Service Bulletin

No. : MZ04-059

Model: SR7400

Subject: Noise from SURROUND L/R Speakers.

File name for Update Disc of 90M-SR7400CD3

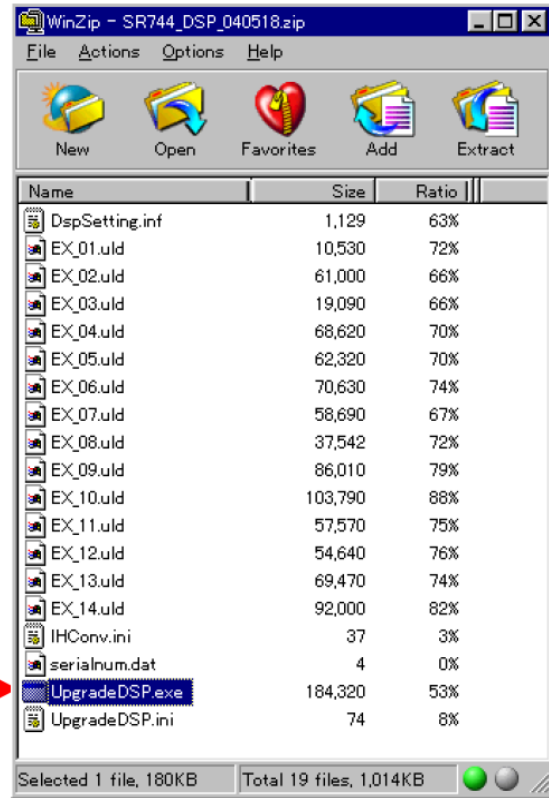
Attention: Please copy the files onto your PC and unzip them before using.

SR7400_CPU_V040218_2.zip

This is used

SR7400_DSP_040518.zip

This is used
